RE: 1801-1821 S. Penmar Ave. & 1169 E. Palms Blvd - Case No. VTT-82077-SL-HCA and ENV-2020-4774-CE
Case File: 21-1495

From: EVNA Venice evna.venice@gmail.com
Subject: Re: Case No. ENV-2020-4774-CE (Council File 21-1495) - URGENT

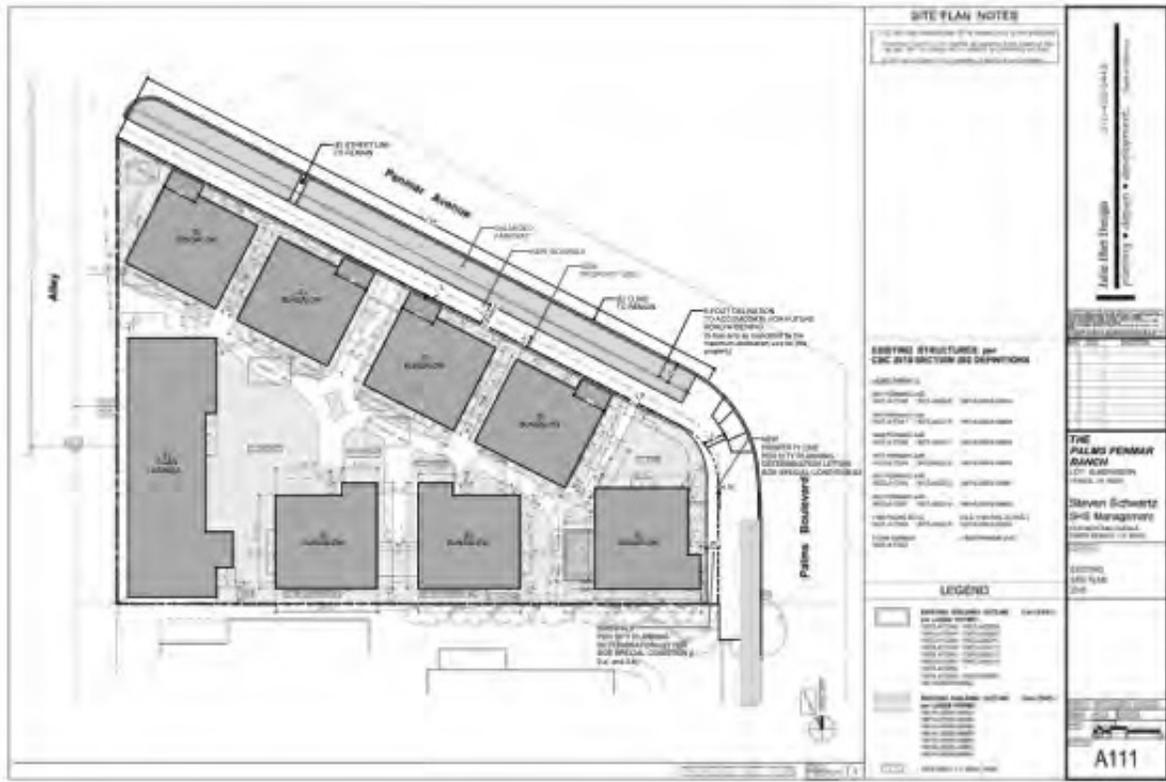
What we suggest for Penmar Avenue, is similar yet slightly different, as we believe that an actual dedication gives the City the best options for future improvements. So along Penmar, if we were to take a 2.5-foot dedication and move the 5-foot sidewalk by 2.5 feet, that would create a larger parkway that could be reduced as necessary in the future.

The current side yard setback of Unit A1-A4 is 3'-2".

Our suggestion would result in a reduction of side yard, from 3'-2" to 9". We understand that this is slightly less optimal than what the City has requested for Palms Blvd, where the new sidewalk will be located at 1'-7" from the building, but Penmar Avenue has a bigger dedication (5-foot vs 3-foot) and a current a much narrower roadway.
